July 30, 2025

PROJECT NAME: ORANGE BLOSSOM REPLAT #1

PROJECT NUMBER: 2025050013

APPLICATION: PRELIMINARY PLAT #32811

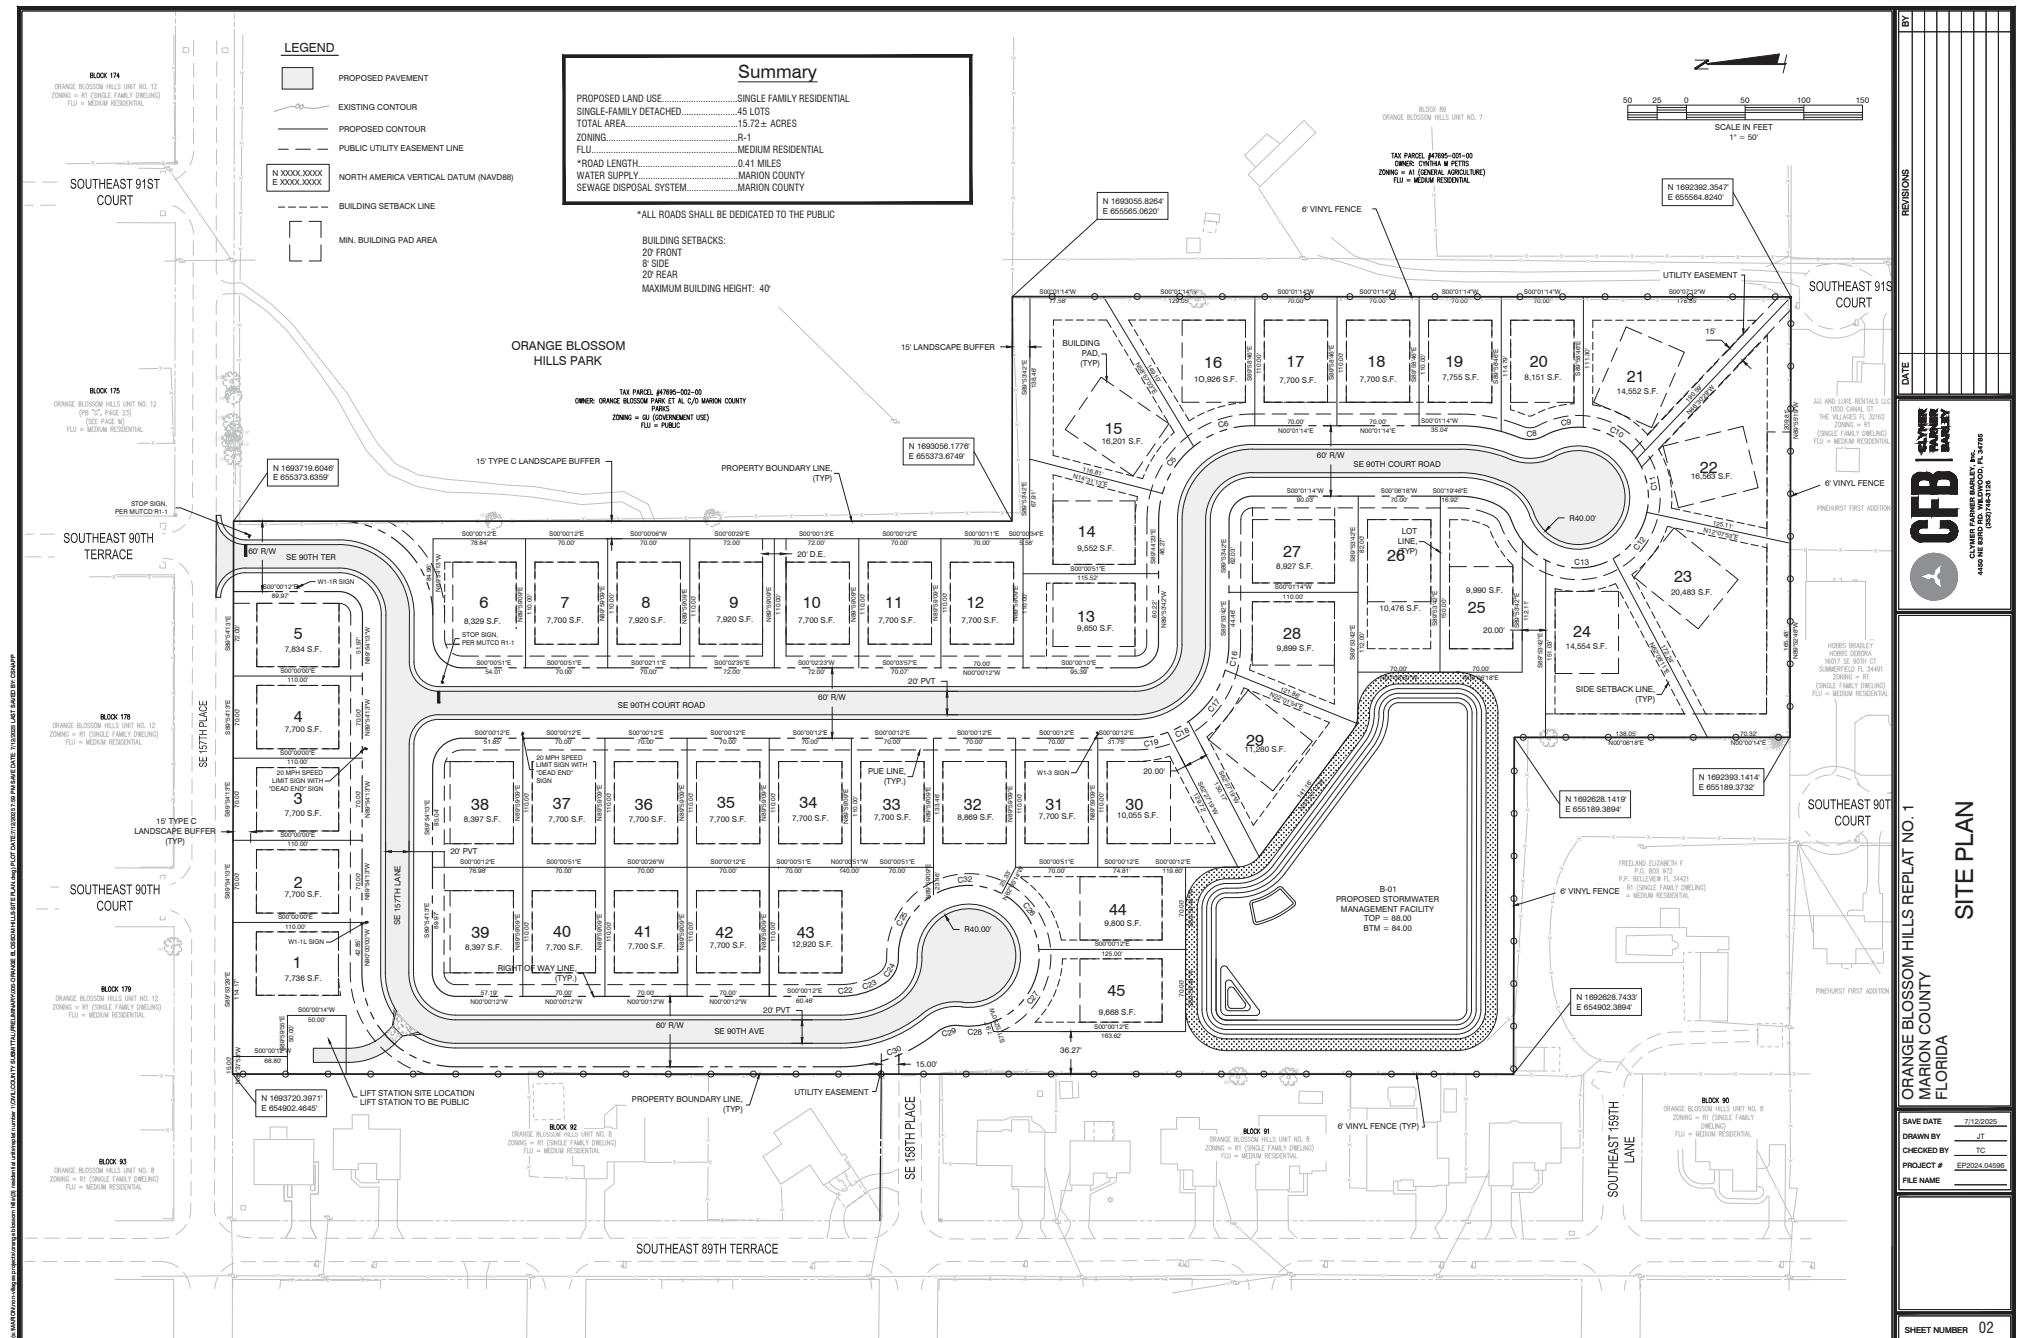
REMARKS: Road names have been added to Sheet 2. Please label accordingly on all future submittals.

REMARKS: Please indicate maximum building height on sheet 02

SHEET NUMBER 03

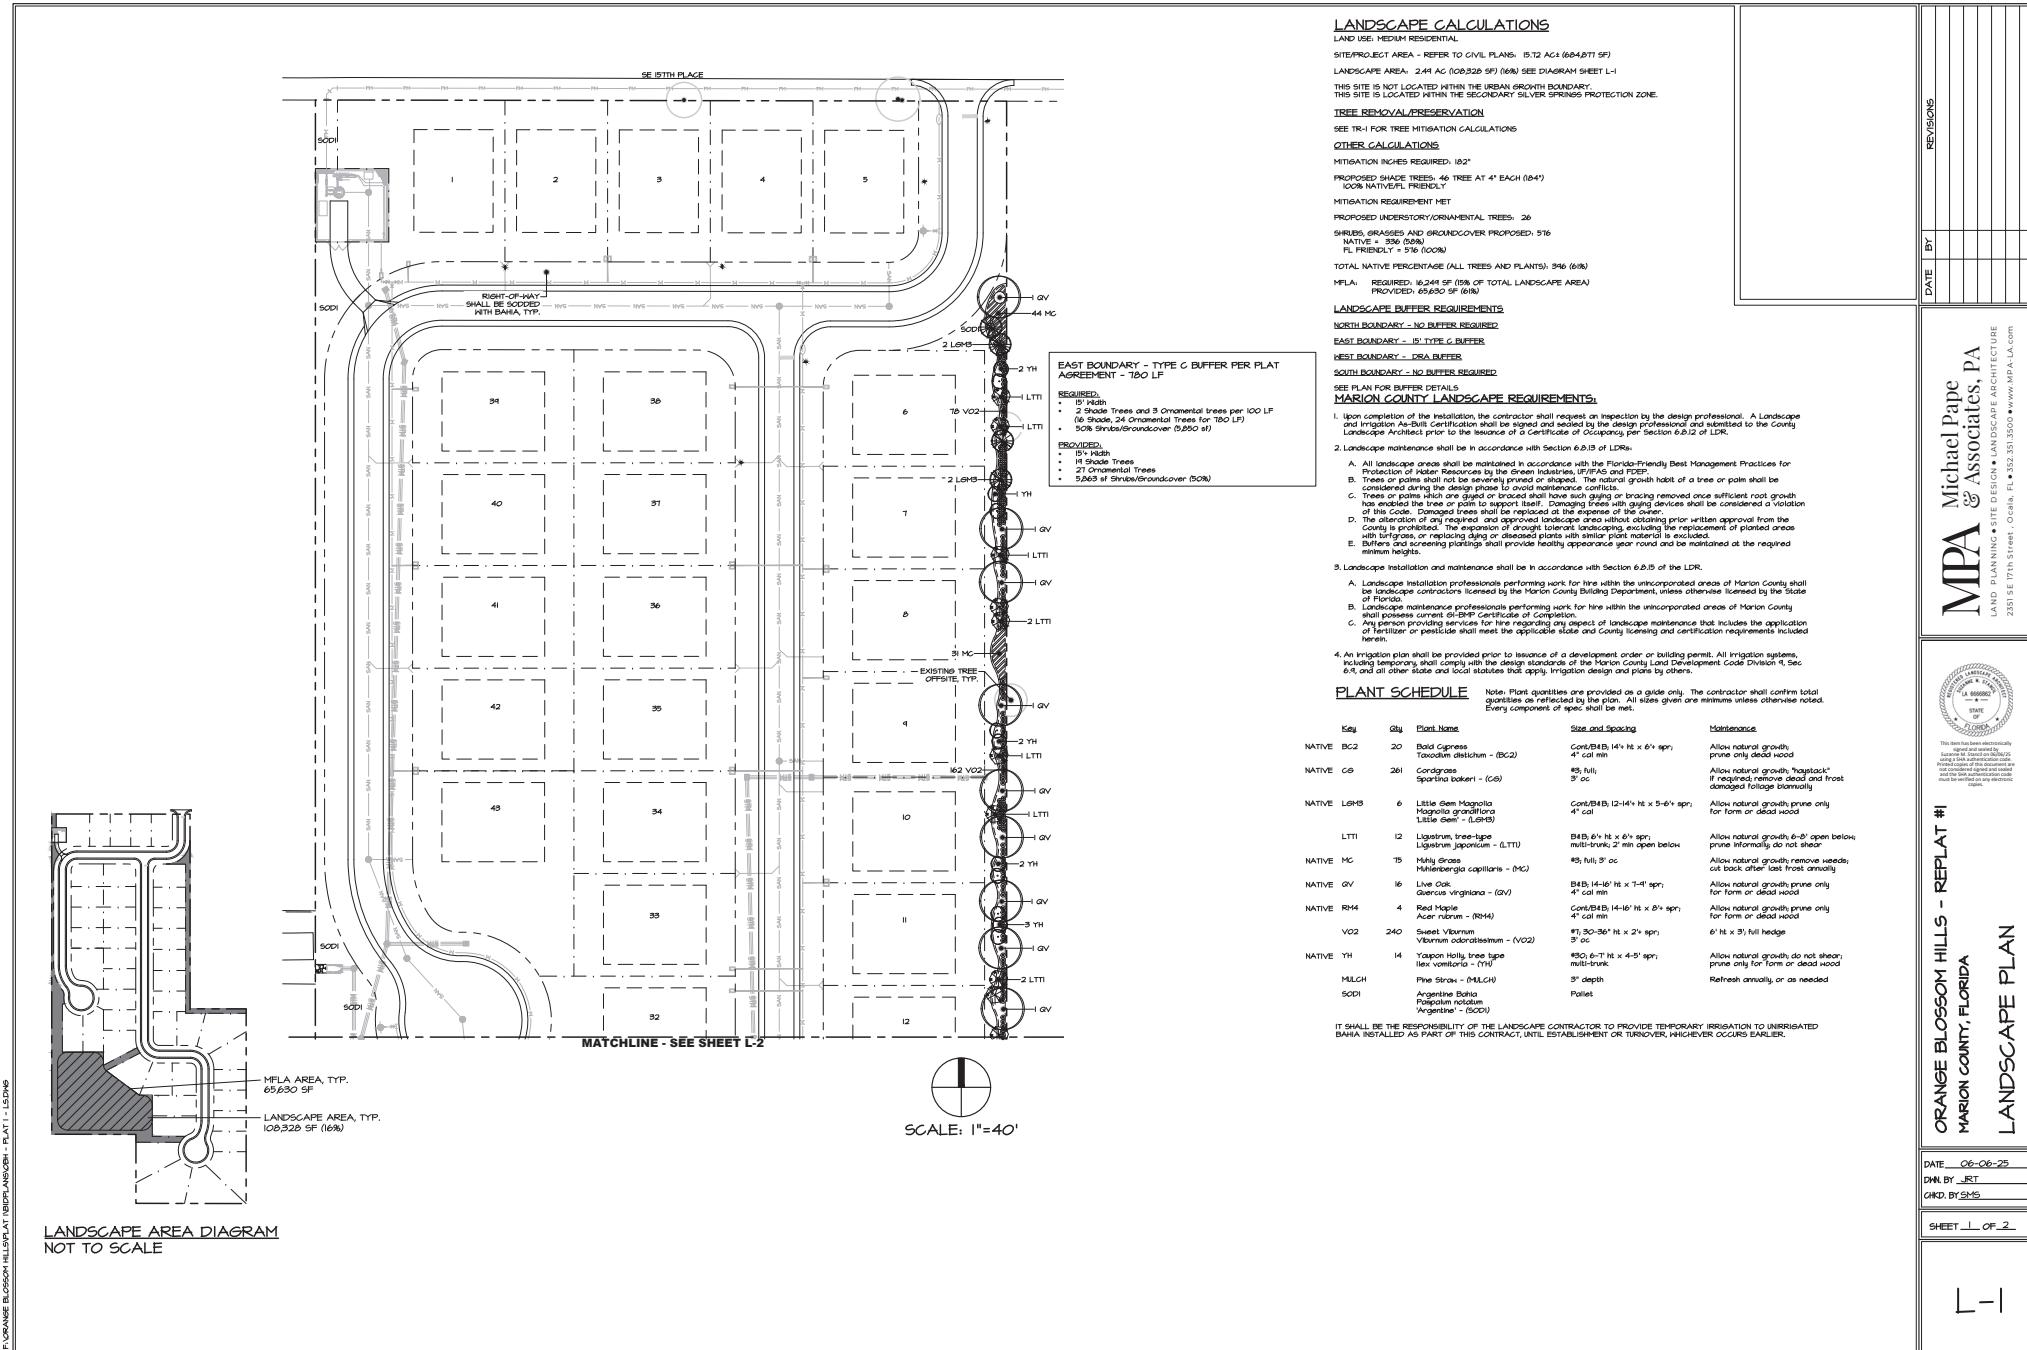
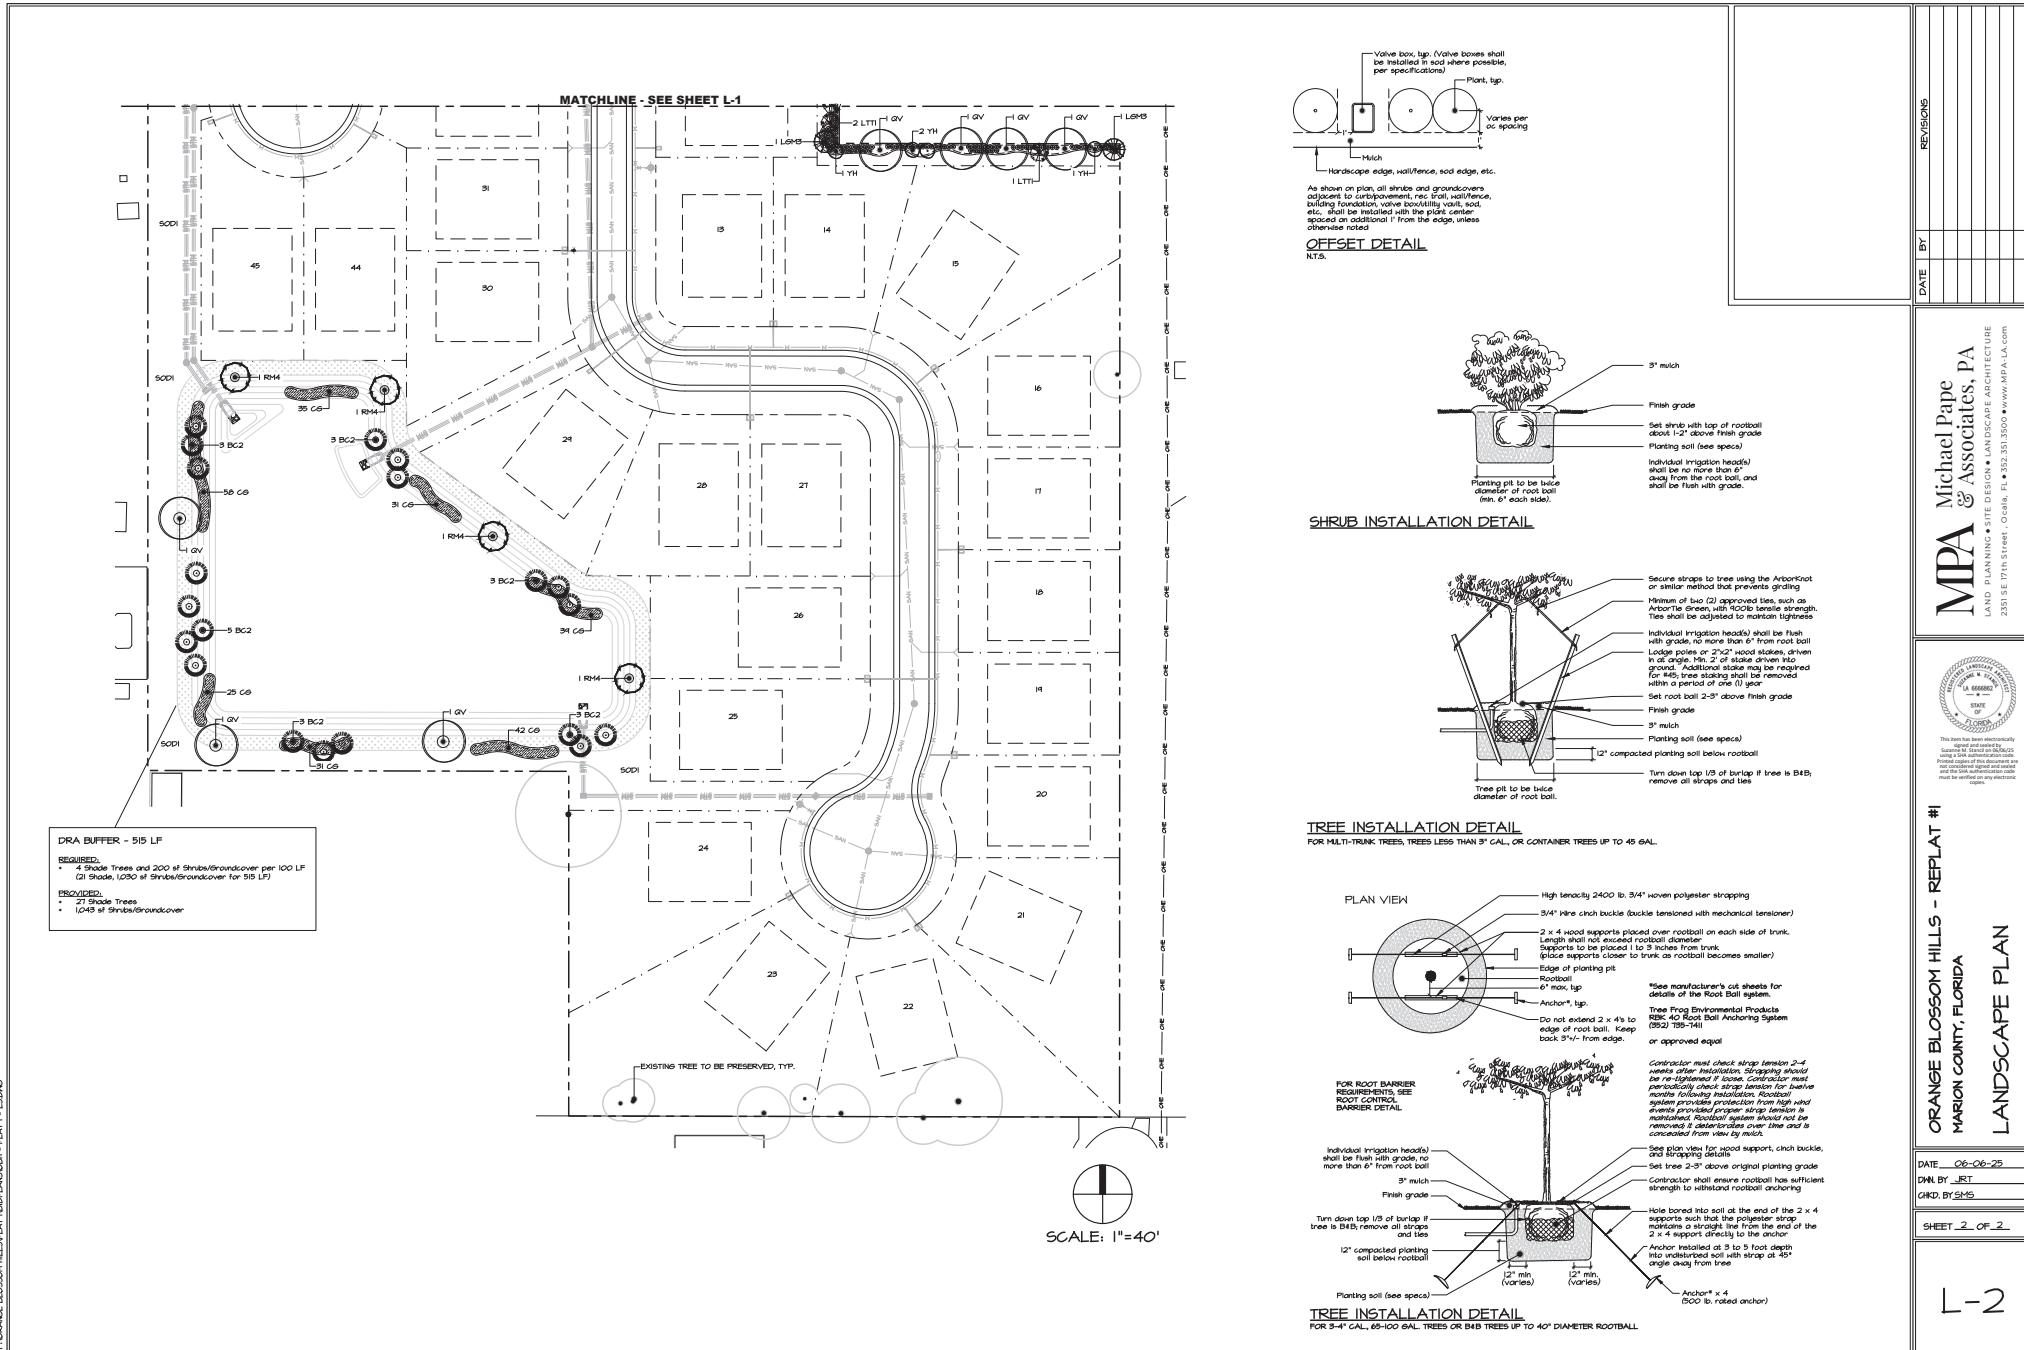
REMARKS: 5/19/25 - 1) Road dedication, whether public or private, must be specified. 2) Centerline radii do not support the minimum required design speed of 30 mph.
